## DOVER PLANNING BOARD – AGENDA

Meeting Type: Regular Meeting  
Meeting Location: Council Chambers, City Hall, 288 Central Ave, Dover NH 03820  
Meeting Date: **Tuesday, October 26, 2021**  
Meeting Time: **7:00 pm**

- C. Consideration and acceptance of a Site Review for Atlantic Broadband, (Owner: Quantum Real Estate Group, LLC), Assessor's Map H, Lot 29A-1, zoned CM, located at Littleworth Road. (Proposal is to construct a 924 sq. ft. Public Utility Building with associated parking, utilities and drainage improvements). \*(P21-63)

Li-1

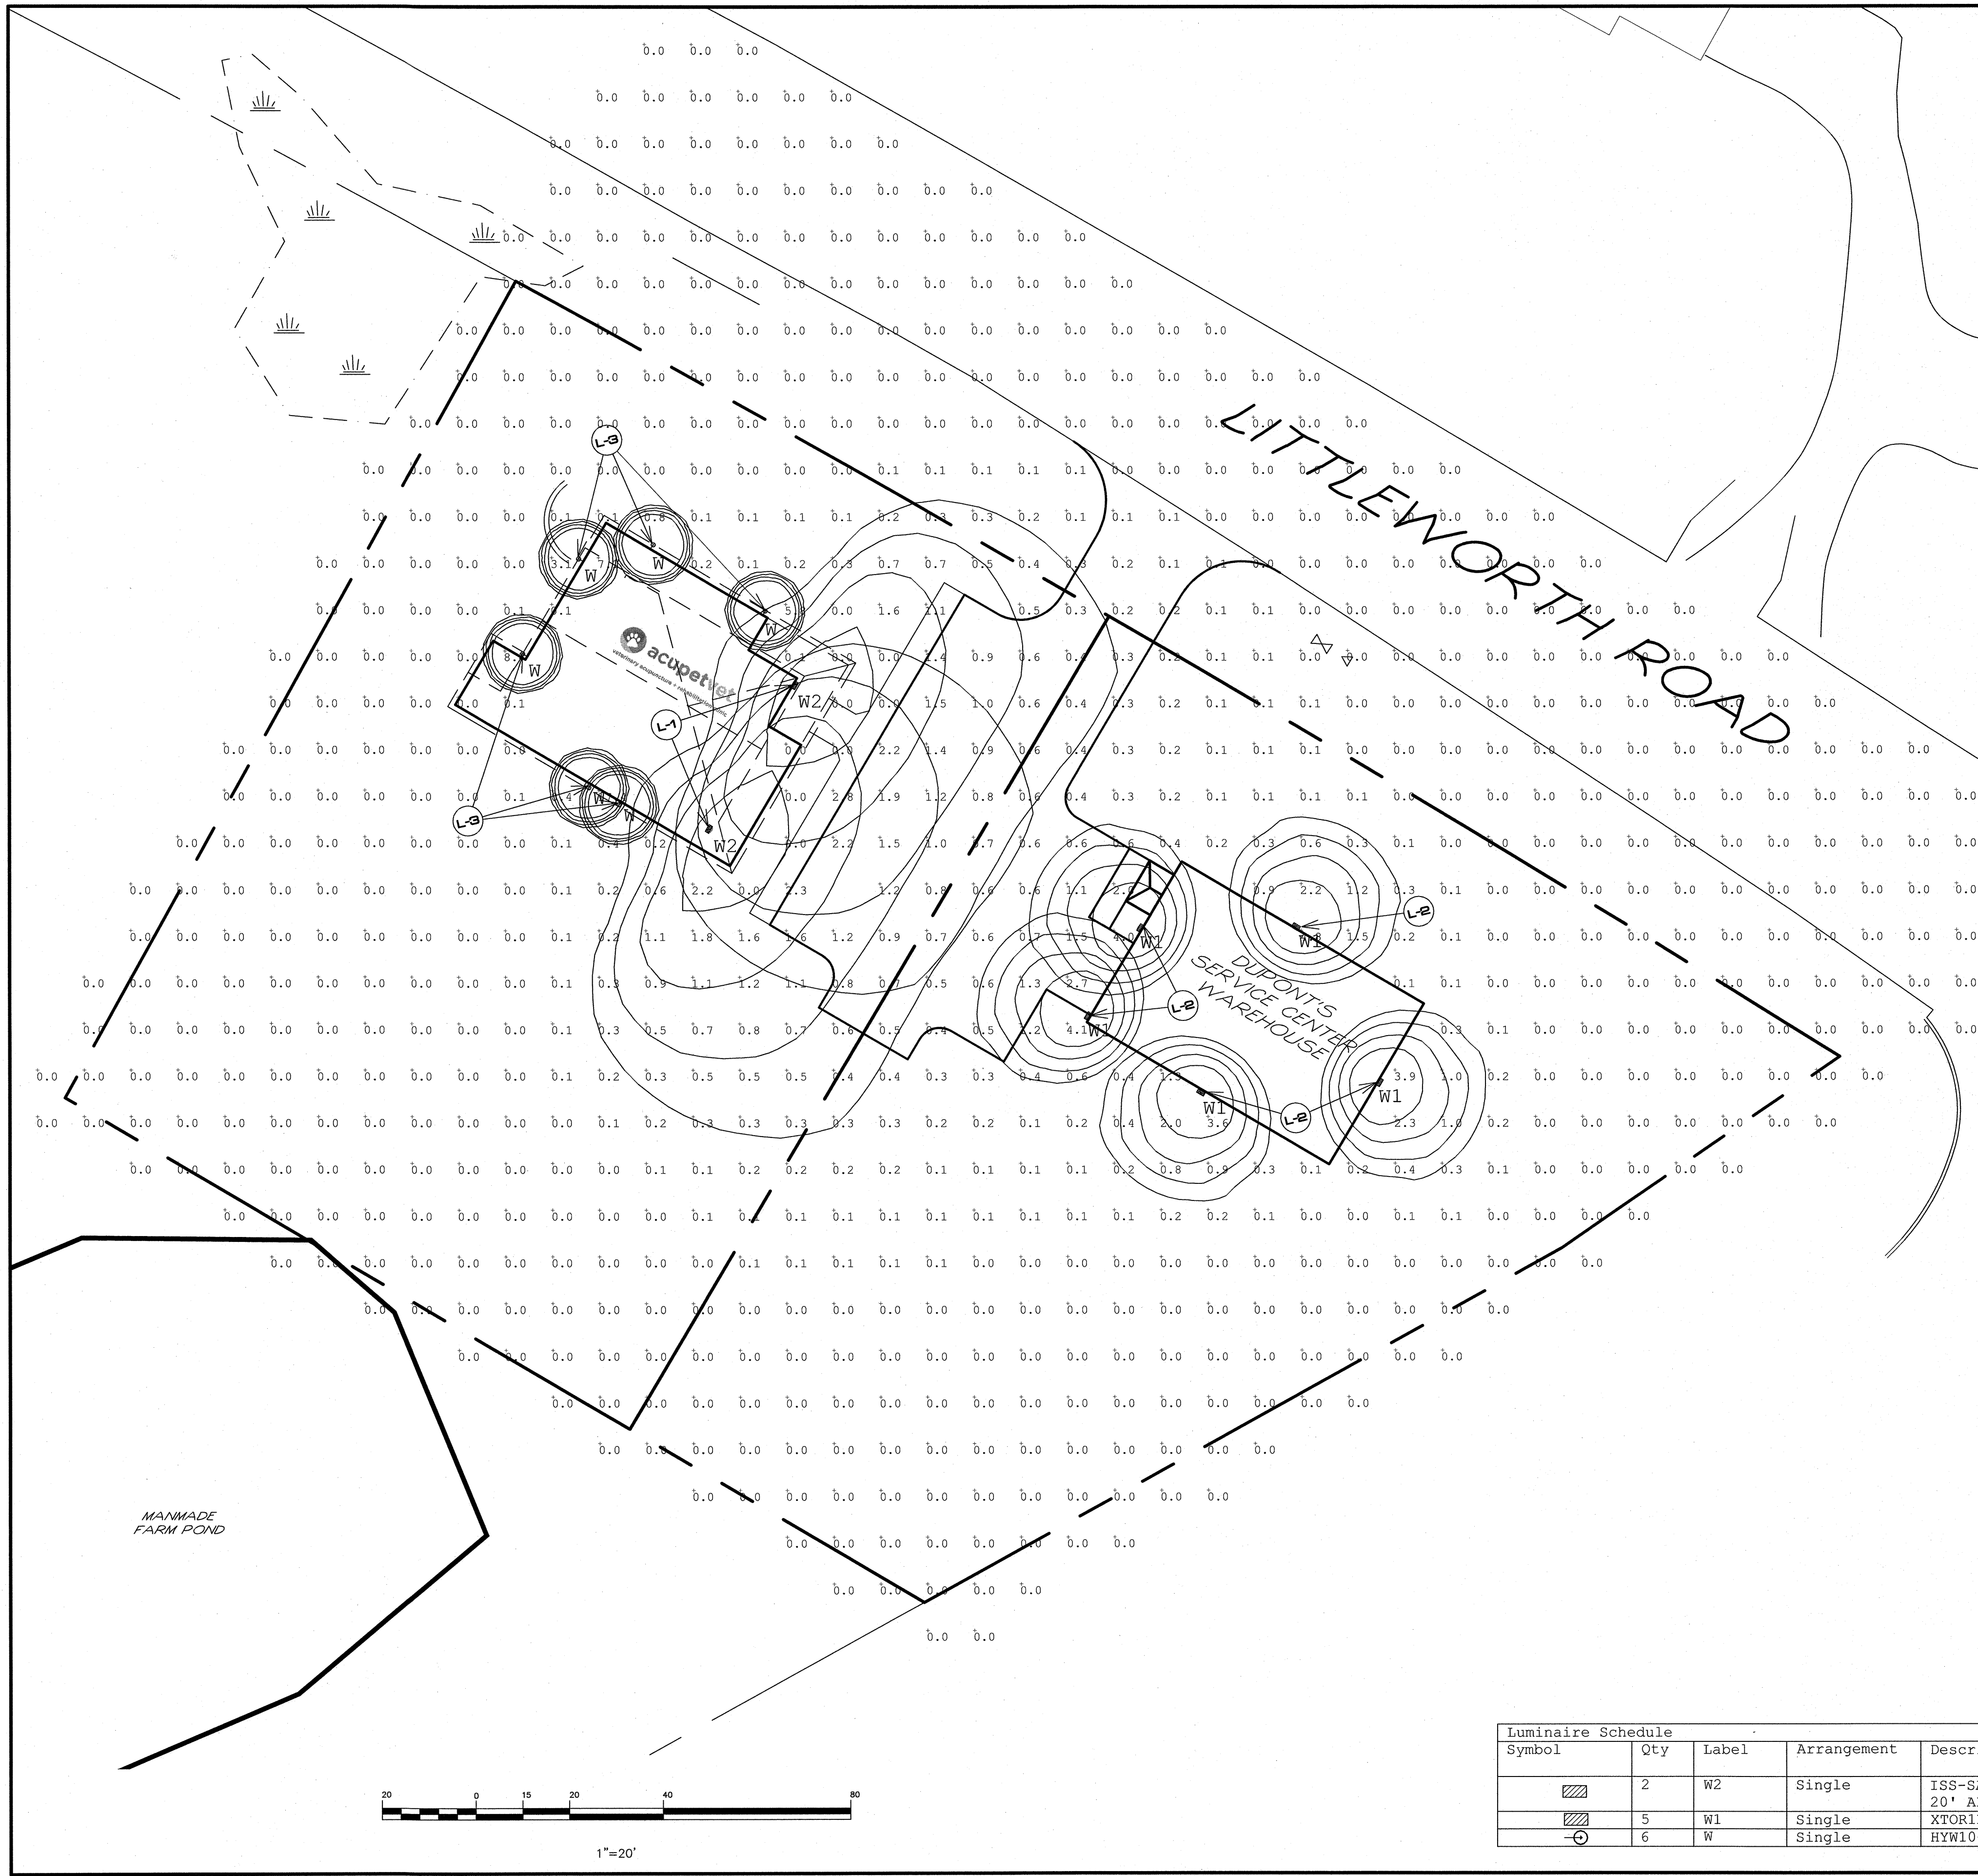
- Add security lighting on all 4 sides of building.  
*Decorative outdoor lighting is depicted on all 4 sides of the building elevations and site plans. Photometrics have been added to Sheet Li-1.*
